**BEFORE THE ILLINOIS POLLUTION CONTROL BOARD**

PETITION OF BRICKYARD DISPOSAL & )  
RECYCLING, INC. FOR AN ADJUSTED ) AS 14-03  
STANDARD PURSUANT TO 35 ILL. ) (Adjusted Standard - Land)  
ADM. CODE 814.402(B)(3) and FROM 35 )  
ILL. ADM. CODE 810.103, 811.318(b)(3) )  
and 811.320(c) )

**PETITIONER’S RESPONSE TO IEPA RECOMMENDATION**

DATE: AUGUST 2014  
 PROJECT ID: 1989-115A  
 SHEET NUMBER:  
**FIGURE 1**

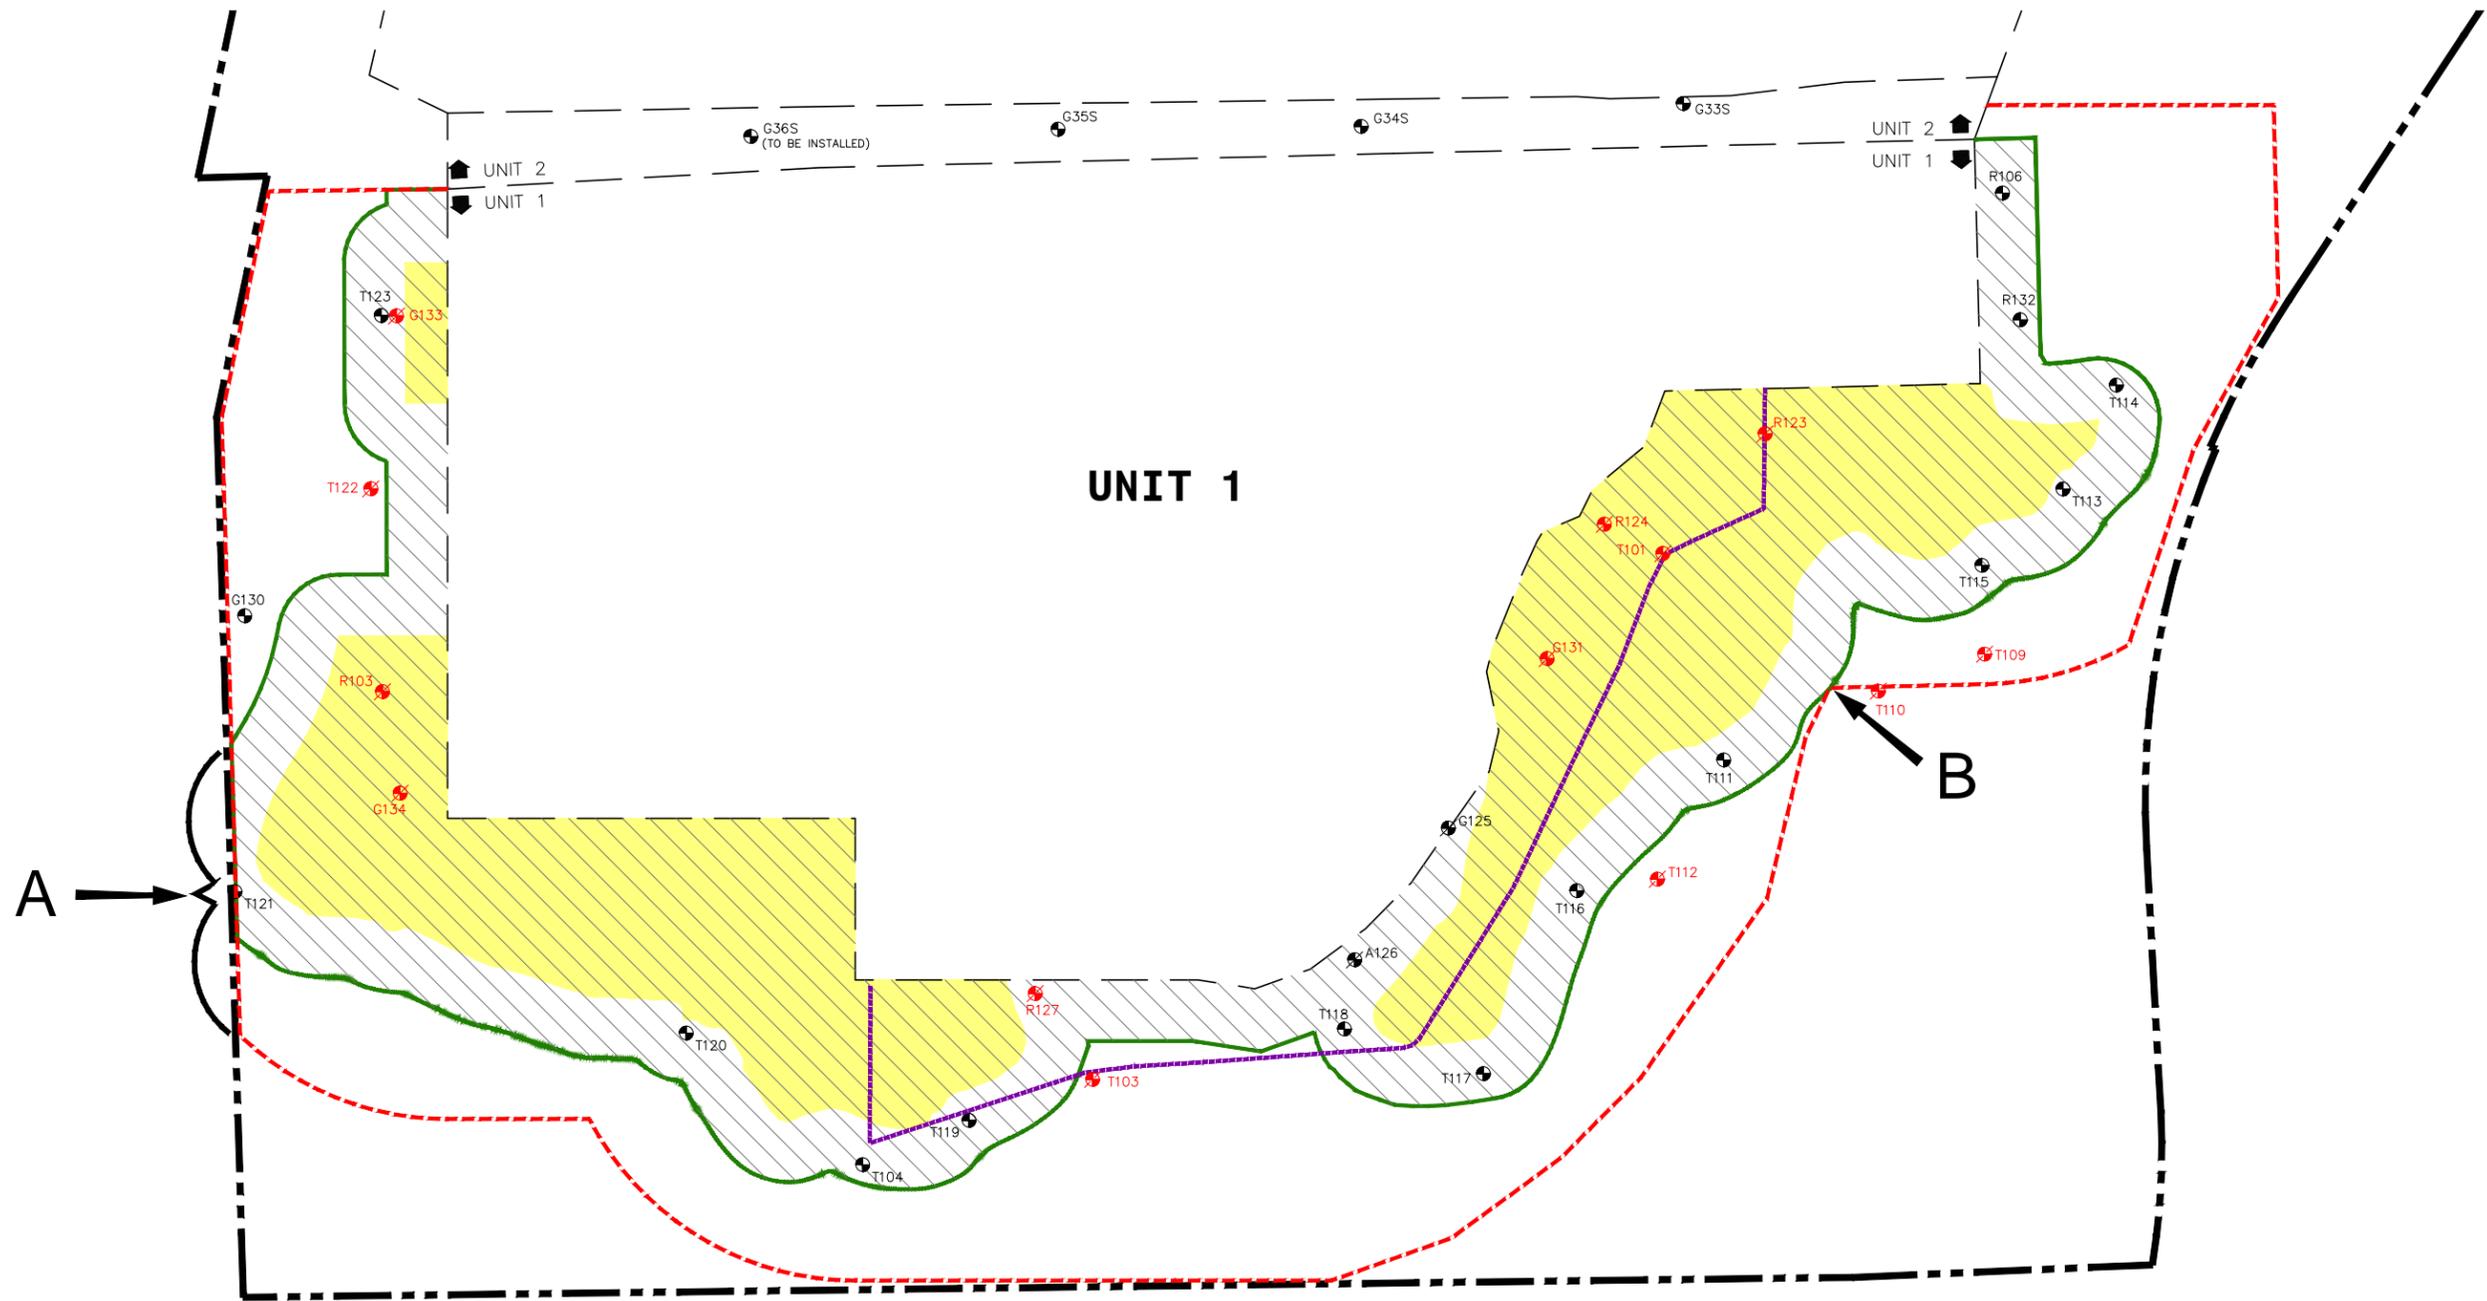
As discussed above, the one area where IEPA correctly points out that the compliance boundary is greater than 100 feet is at the southern end. Brickyard initially proposed the southern boundary consistent with the existing GMZ boundary, as opposed to the 100 foot (or less) utilized for the rest of the compliance boundary. That it did so is clearly evident from the petition, on the note found at Exh. A., Figure 1. Brickyard's rationale for doing was to maintain consistency of both boundaries in that area: the GMZ and the proposed compliance boundary. However, as the IEPA has taken issue with this approach (see Rec., pars. 42-25), Brickyard has agreed to redraw the line in a manner that is 100 foot (or less) throughout the entirety of the relevant area, notwithstanding the GMZ. Brickyard makes this accommodation in its Response and, accordingly, presents a revised proposed Board Order and revised attached Exh. A, Figure 1. The change is also evident in Illustration 2, discussed above.

1. The compliance boundary for Brickyard Unit I is adjusted to the line as shown in attached Figure 1, dated August 2014, which is 100 feet or less from the boundary of Brickyard Unit I or the identified area containing extraneous materials, whichever is relevant.
2. The definition of "zone of attenuation" from 35 Ill. Adm. Code 810.103 is modified as applied to Brickyard Unit I as follows:
